CITY OF POMONA

DEVELOPMENT SERVICES DIRECTOR REPORT

SUBJECT: DEVELOPMENT PLAN REVIEW (DPR 10697-2018): An application for

Development Plan Review (10697-2018) requesting a façade and interior tenant improvement at an existing drive-through restaurant (Jack-in-the-Box) at 101 West Foothill Boulevard in the City Gateway Segment of the Pomona Corridors

Existing Building

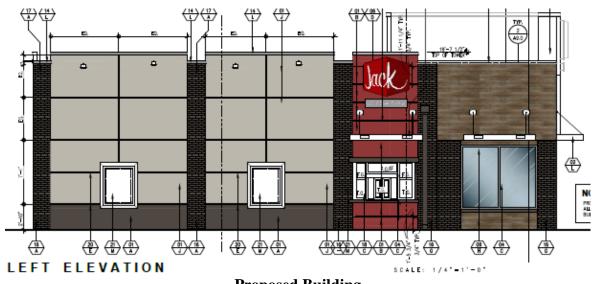
The existing restaurant building is styled with wood shingled roof and painted bricks for its exterior façade. There is a red border on top of the roof and large overhang at the bottom of the roof. The overall height of the building is 17 feet.
